| RE: <b>Recall Campaign 20180 100 10<br/>Launch Notification<br/>Replace B-Pillar Tire Label<br/>MY16 MY17 166 (GLE550e)</b> | DATE: February 9, 2018   |

Campaign No. 2018010010, February 2018

SUBJECT: **Model 166 Model Years 2016-2017**  
**Replace B-Pillar Tire Pressure Label**

Figure 1 (Sample information label)

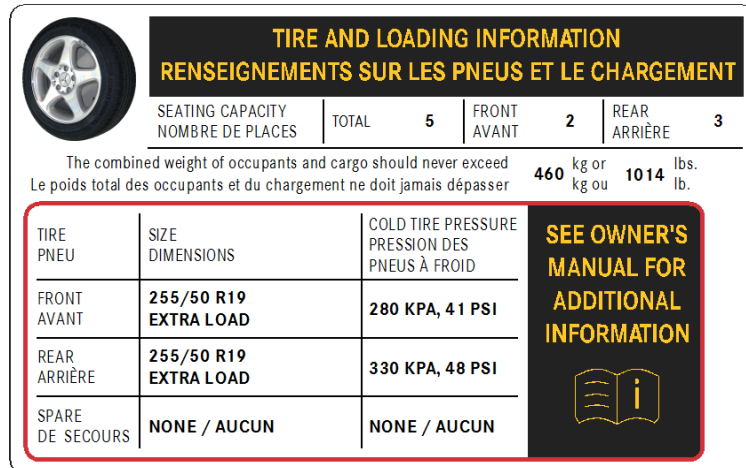
Daimler AG ('DAG'), the manufacturer of Mercedes-Benz vehicles, has determined that certain GLE-Class vehicles (166 platform) were fitted with an incorrect tire pressure label at the B-pillar that lists incorrect seating capacity figures and tire dimensions on front and rear axles, and therefore fail to comply with FMVSS 110 (Tires Selection and Rims). As a precautionary measure an authorized Mercedes-Benz dealer will check the tire pressure label at the B-pillar on the affected vehicles and replace it, if necessary.

1. Remove existing information label from B-pillar.
2. Remove any adhesive residues and clean bonding surface.
3. Apply new information label in the same position.
